LISTED BUILDING CONSENT			
Client: Mr. Simon Dougall			
Project Title: 107 High St, Lindfield, Haywards Heath, West Sussex, RH16 2HR			
Drawing Title: Detail Drawings: Partition for ground floor WC			
Scale: 1:25@A1 1:50@A3	Date: Apr 25	Drawn: KN	Checked: KW

kyson ^{studio}		
Studio 28 Scrutton Street London UK EC2A 4RP T: +44(0) 20 7247 2462 E: enquiries@kyson.co.uk W: www.kyson.co.uk		
Project No.: 900-25	Drawing No.: 5004	Revision: A

'As Built' and Proposed
Ground Floor Plan
Scale 1:25@A1 , 1:50@A3

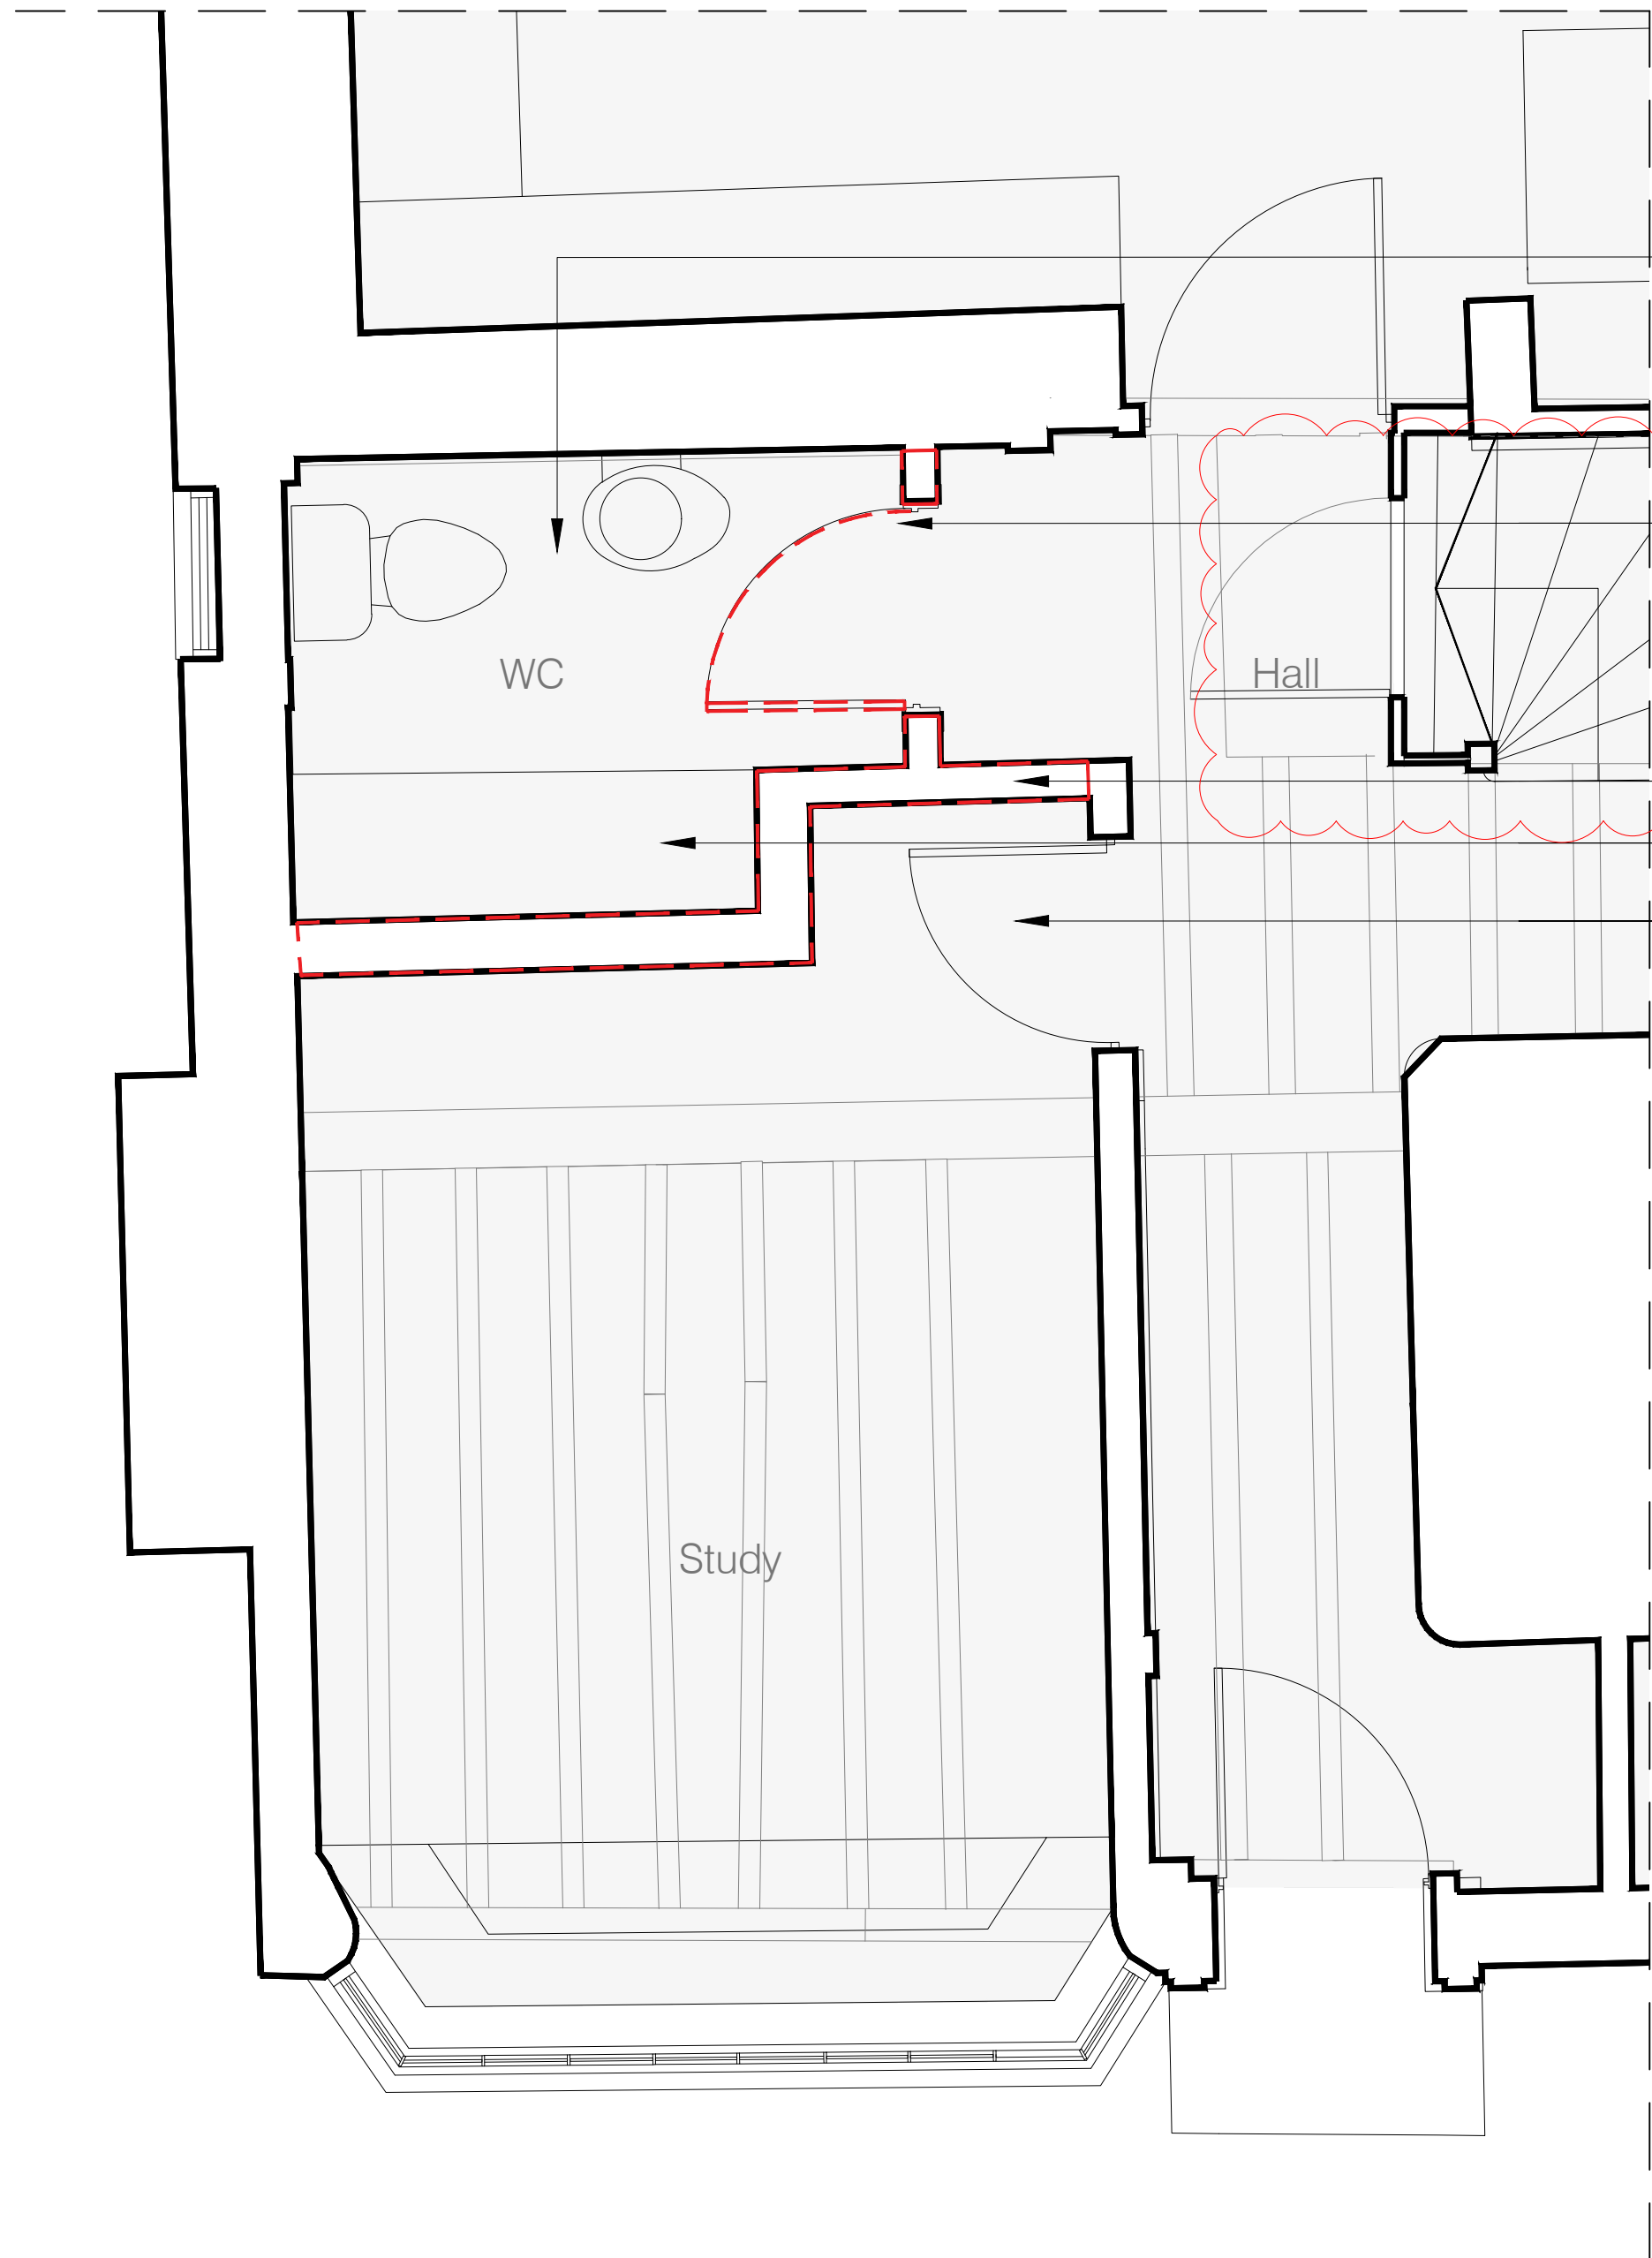
- WC installed in accordance with proposals outlined in planning statement as approved in application DM/22/3695
- New door constructed by re-using spare floorboards found in the attic, finished in a manner to compliment the character of the listed building
- New lath and plaster partition wall
- Fitted joinery to provide essential cloaks storage
- Door handed in existing frame to make better use of the space
